3 SUBMISSION RESPONSES

Approach to Addressing Issues Raised in Submissions

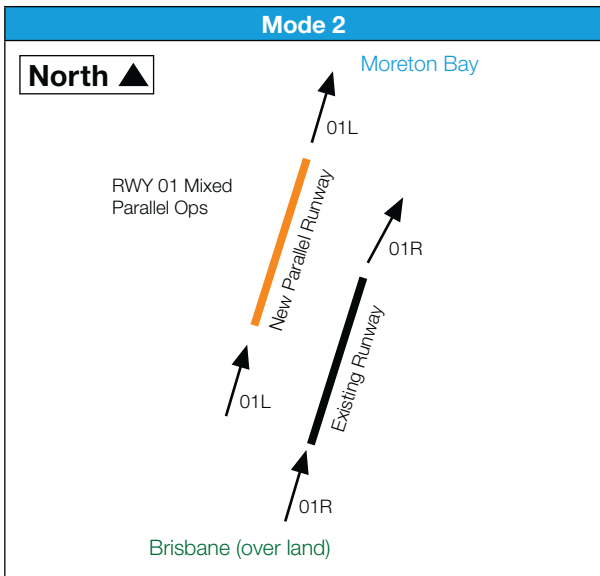
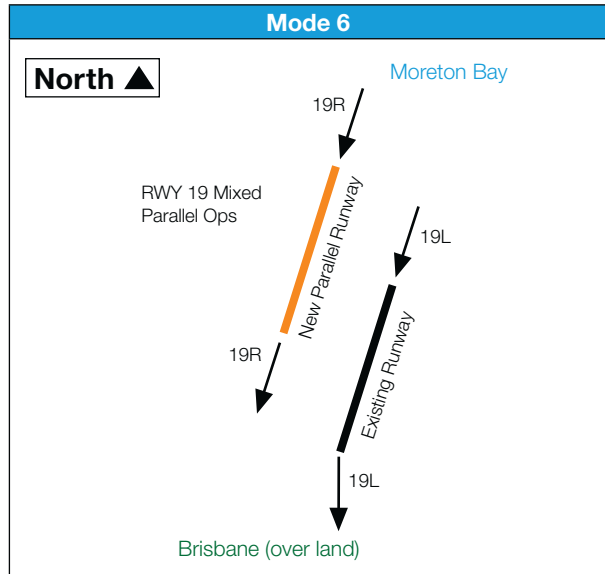
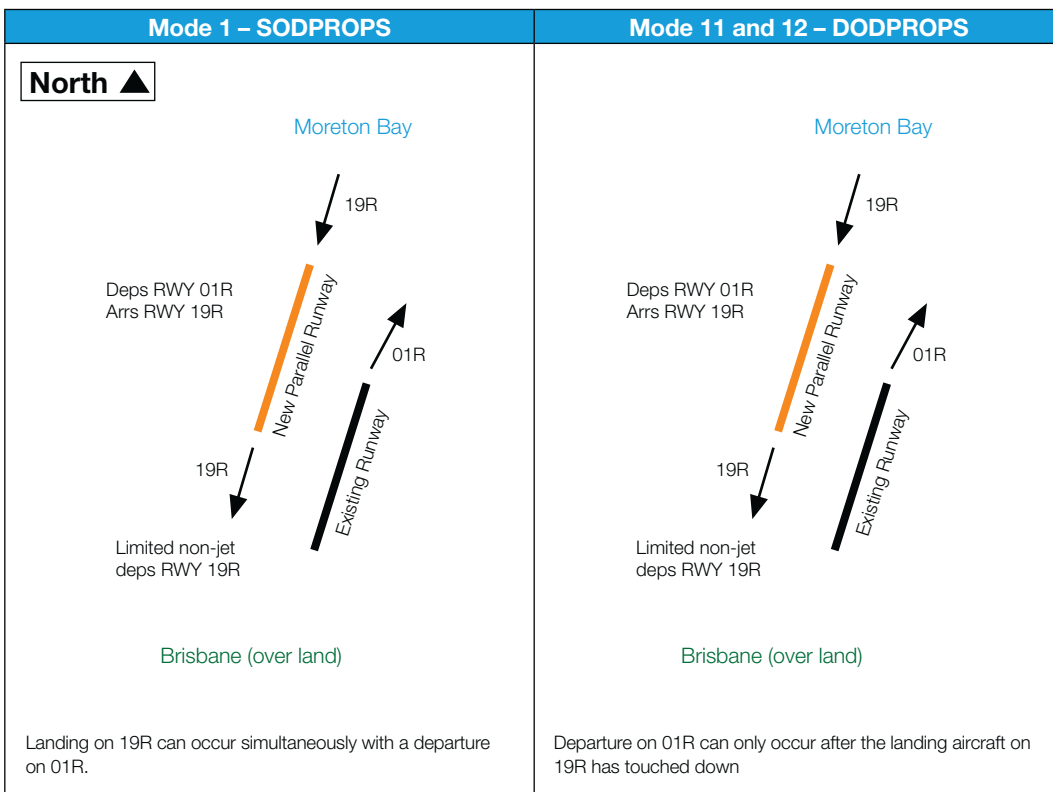
A number of submissions query the separation between the runways. The most prevalent comment (36/41) is to have the new runway located at 1525 metres from the existing main runway. The majority of the submissions (36/41) are from the suburbs directly west of the New Parallel Runway centreline and include Nudgee Beach, Nudgee, Banyo, Northgate and Nundah.

The International Civil Aviation Organisation’s (ICAO) specification outlined in its Manual on Simultaneous Operations on Parallel or Near-Parallel Instrument Runways (SOIR) sets for a number of different runway operating modes the, runway separation distances, navigation/radar capability, weather conditions, and a range of other issues relating to safety like air traffic control procedures and pilot training. The SOIR addresses the following modes of operation:

The preferred modes of operation being proposed for Brisbane with the New Parallel Runway termed “over bay operations” are SODPROPS (Simultaneous Opposite Direction Parallel Runway Operations - Draft EIS/MDP Mode 1) and DODPROPS (Dependent Opposite Direction Parallel Runway Operations - Draft EIS/MDP Mode 11) which Draft EIS/MDP noise modelling has shown will be used during the night time period (10pm to 6am) which will allow aircraft to arrive and depart simultaneously over the bay affording noise mitigation over residential Brisbane. There is no ICAO standard for runway separation distances for the application of SODPROPS.

The SOIR separations do not apply to SODPROPS. To suggest that the SOIR and the separation distances discussed therein is relevant to the New Parallel Runway and the operation of SODPROPS is incorrect.

Figure 3.3a: Runway Options from the 2003 Master Plan.

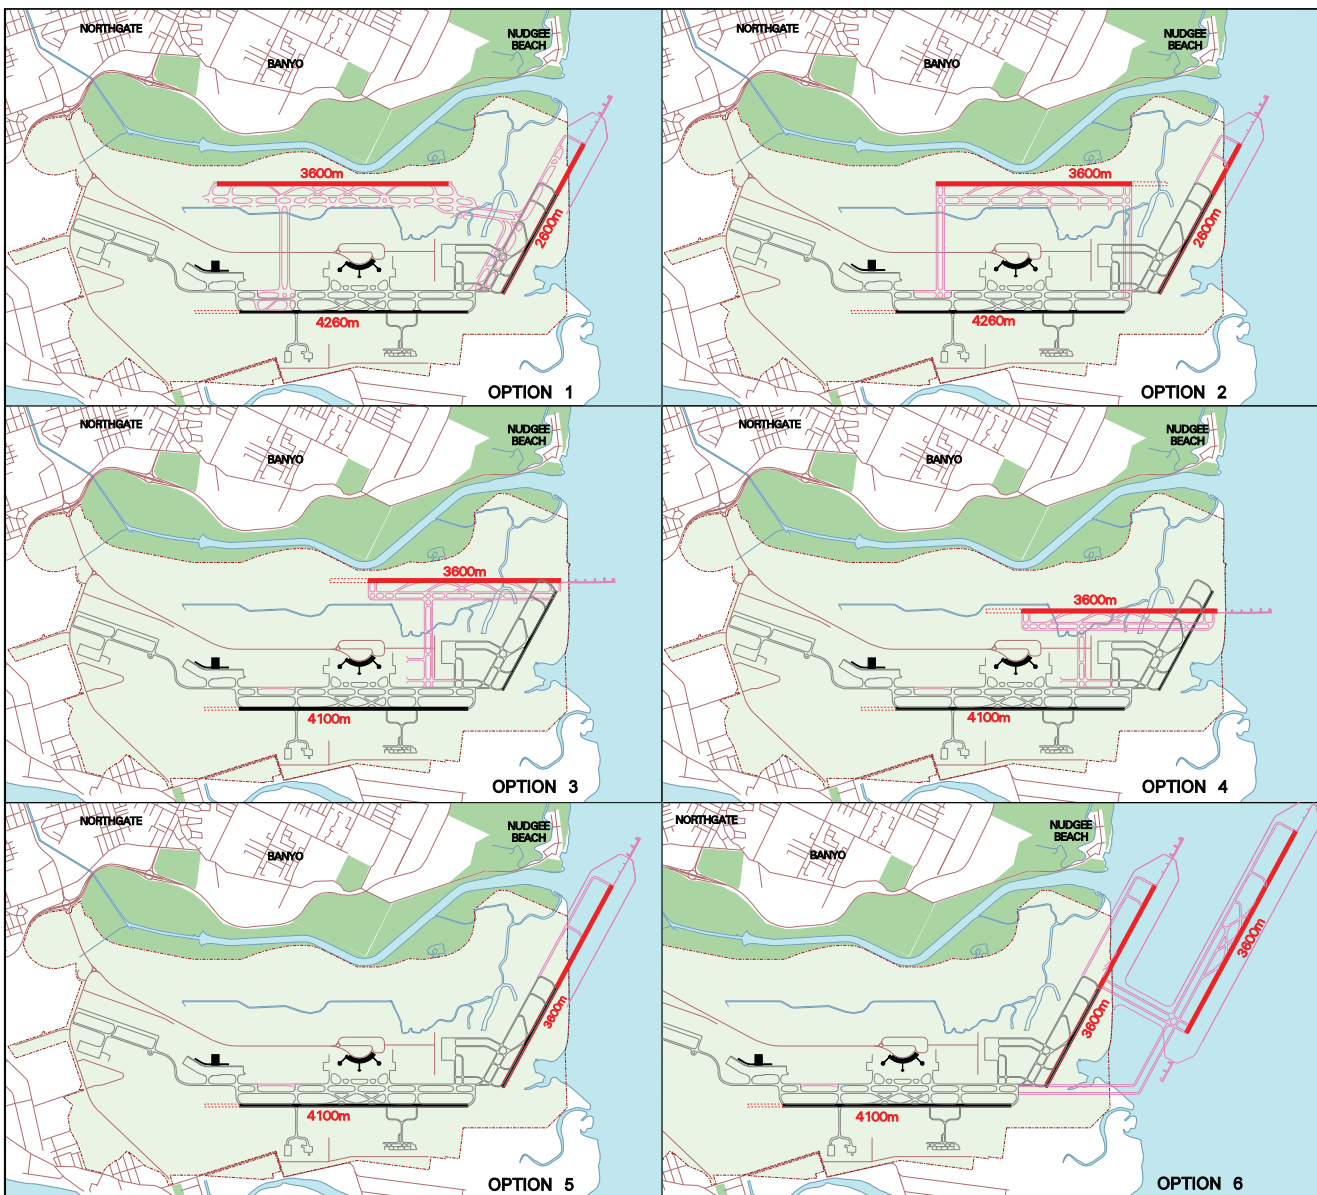
This section of the Supplementary Report deals with submitter comments in relation to Section 3.3 of the Draft EIS/MDP as well as submitters who put forward additional runway options to those canvassed in the 2003 Master Plan.

Brisbane Airport Master Plans have shown a parallel runway system separated by 2000 metre as the preferred configuration for the Brisbane Airport site since 1983. The preferred runway layout as taken forward in the Draft EIS/MDP (option 3), was developed on the basis of a range of studies and analysis undertaken as part of previous Master Plans. The 2003 Master Plan undertook an analysis of the benefits and disadvantages of all six runway configurations, identifying option 3 as the preferred layout based on relevant economic, social and environmental considerations.

Figure 4.14a: Figure showing indicative cross-section of proposed seawall from Cribb Island Jetty to Serpentine Inlet.

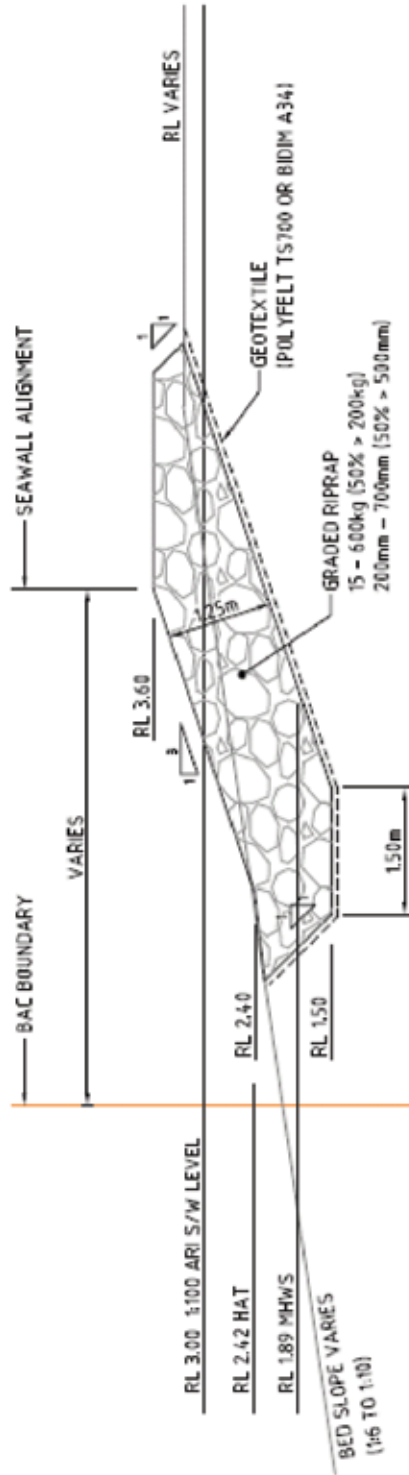
An additional preliminary design plan for the seawall has been included in this section of the Supplementary Report to address the comment by the submitter.

- That new Figure 4.14a (refer Maunsell Drawing #'s 10302405-SK369) be added to list of figures in Chapter A4 of the Draft EIS/MDP.
